MANDATORY SERVICE BULLETIN

NO. MSB 42-083

NO. MSB 42NG-014

Replacement of the passenger door retaining bracket.

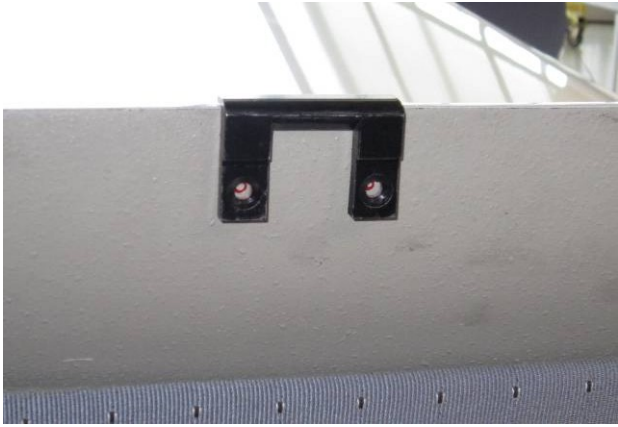
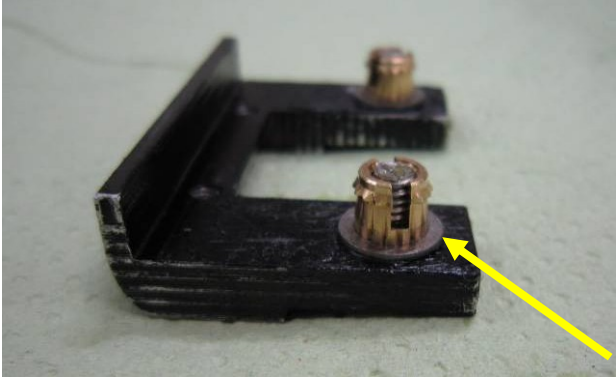
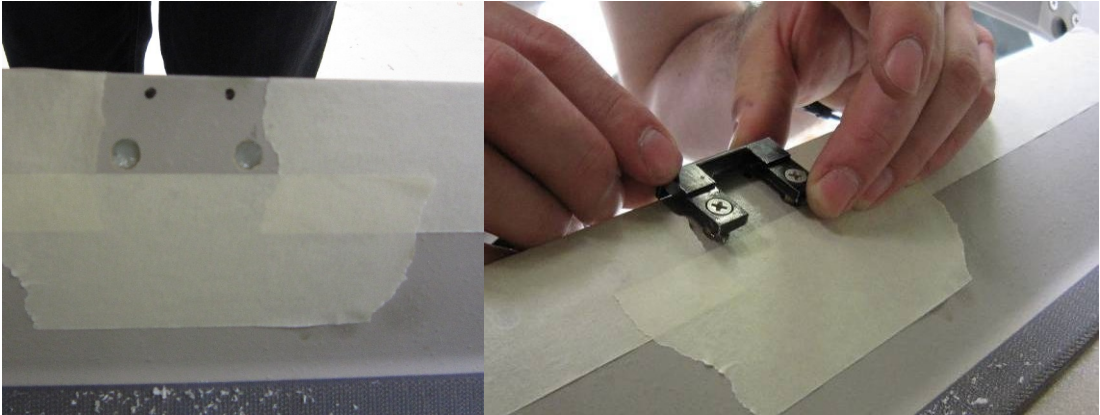
An improved retaining bracket for the door safety hook has been designed, together with an amended emergency procedure, to prevent opening and most likely detaching of the door during flight with an unlatched door. This Service Bulletin describes the retrofit installation of the retaining bracket on aircraft already in operation.

1	<p>If the Retaining Bracket P/N: DA4-5200-00-69_1 is installed (refer to picture), ensure the function acc. to AMM-TR-MÄM-42-334. No further action necessary.</p> <div data-bbox="612 667 1075 840" data-label="Image"></div> <p data-bbox="683 875 995 904">P/N: DA4-5200-00-69_1</p>
---	---

2	<p>Remove the two screws from the fuselage which hold the Retaining Bracket (P/N: DA4-5200-00-69).</p>
3	<p>Install the Retrofit Retaining Bracket (P/N: DA4-5200-00-69-SB) on the old position and mark the position of the two holes from inside the fuselage.</p> <div data-bbox="529 1279 1150 1704" data-label="Image"></div>
4	<p>Remove the Retaining Bracket and drill the two holes with a diameter of 7mm (9/32 inch) and a depth of 7mm (9/32 inch) on the marked positions.</p>

5	<p>Prepare the Retaining Bracket for bonding the thread Insert. Grease the Retaining Bracket, the screws and the washers. Clean the thread insert from grease and dirt.</p>  <p style="text-align: right;">Washer DIN 125</p>
6	<p>WARNING: When handling chemicals always observe Health and Safety Regulations given by the manufacturer of the chemicals.</p>
7	<p>Fill the holes with the two-part adhesive MA300 and install the Retaining Bracket</p> 
8	<p>Let the installation cure for one hour.</p>
9	<p>Remove the Retaining Bracket and carefully remove the washers DIN 125.</p>
10	<p>Install the Retaining Bracket with screws DIN 963 M3x12-A2-BC and DIN 965-AM4-10-A2.</p>
11	<p>Check function of door locking mechanism refer to AMM-TR-MÄM-40-377.</p>
12	<p>Clean the working area and check for foreign objects.</p>
13	<p>Ensure Temporary Revision AFM-TR-MÄM 42-443 has been incorporated into the Airplane Flight Manual.</p>
